for MITSUI—MAN B&W engines, New replacement criteria of PC ring		No.108	
		APPROVED	H.Sakamoto
		CHECKED	Y.Ishida
		PREPARED	I.Tanaka
ENGINE TYPE	All	DATE	9 June 2020

We would like to introduce the new replacement criteria of Piston Cleaning (PC) ring.

= The relation between PC ring[231F-66] and Gasket[231F-15] ([]: REG No.) =

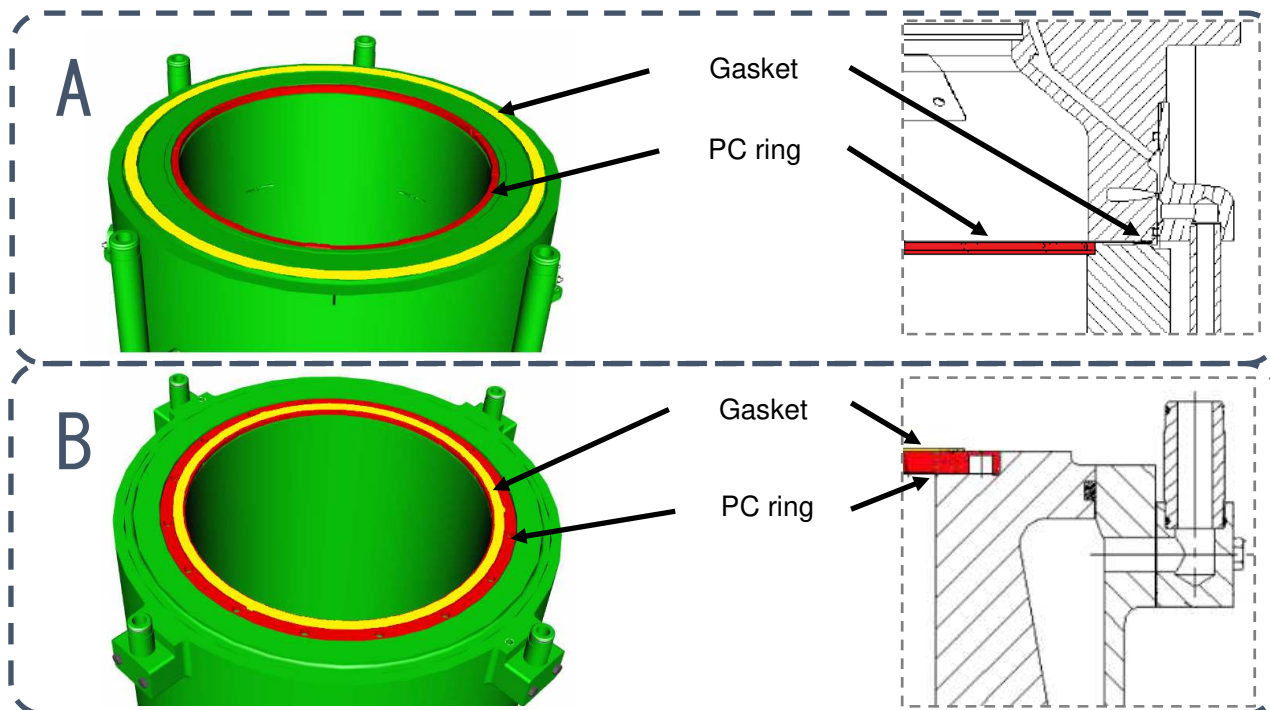
As shown in Figures A and B on the next page, the gasket mounting position depends on the engine type. Previously, we have provided guidance to remove the PC ring in case of A, or to install the dummy ring in case of B, when the wear amount of the cylinder liner exceeds 0.2% of the cylinder diameter. From now, we recommend not operating the main engine with the PC ring removed for A or with the dummy ring installed for B, with the exception that the PC ring is cracked or broken, in order to prevent scuffing due to bore-polish.

If the PC ring is undamaged, it is possible to continue using the PC ring at the original position in the future. When removing the PC ring, make sure to mark the position on the cylinder liner and PC ring to allow fitting of the PC ring in the same position as it is worn together with the cylinder liner. After mounting the PC ring, confirm there is no contact between PC ring and piston crown by operating the turning gear both clockwise and counterclockwise around TDC.

In the case that the PC ring is cracked or broken, please note the following:

- If the cylinder liner wear is below 0.1% of the nominal diameter, replace the PC ring with a new standard PC ring.
- If the cylinder liner wear is above 0.1% of the nominal diameter, replace the PC ring with a new oversized PC ring. When ordering an oversized PC ring, please inform us of the actual data for cylinder liner wear (measured).
